TECH NOTE

AUDI & VOLKSWAGEN SERVICE INFORMATION

BULLETIN: TSB009_AU

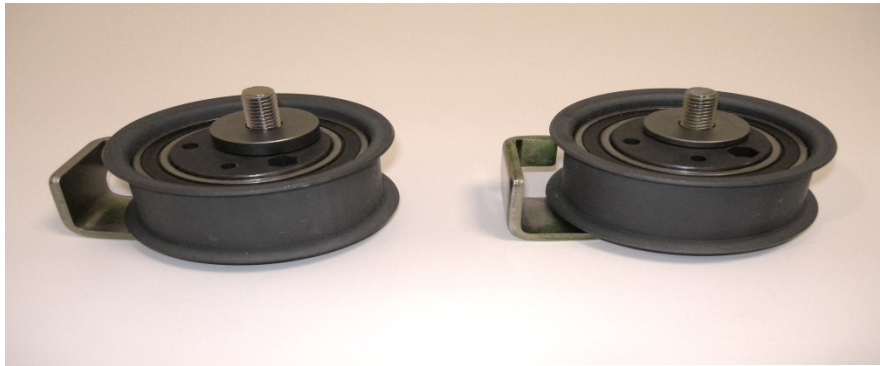
The OE system that is no longer available from the manufacturer is illustrated in Fig #1. The updated system, contained in Gates TCKH317A, which includes the redesigned hydraulic actuator, tensioning roller and 153 Tooth timing belt (Gates T317) is illustrated in FIG #2.

A 152 tooth belt (T291) CANNOT be combined with the updated components pictured below (Fig. 2). And a 153 tooth belt (T317) cannot be placed on the older version of the drive set up without risking engine damage (Fig. 1).

Please be aware that the updated drive system design requires a different timing belt. Those vehicles equipped with the old design will have a 152 tooth timing belt (T291). The updated design makes use of a 153 tooth belt (T317). This 153 tooth belt combined with the components contained in a Gates timing component kit will set the drive in the current OE approved configuration.
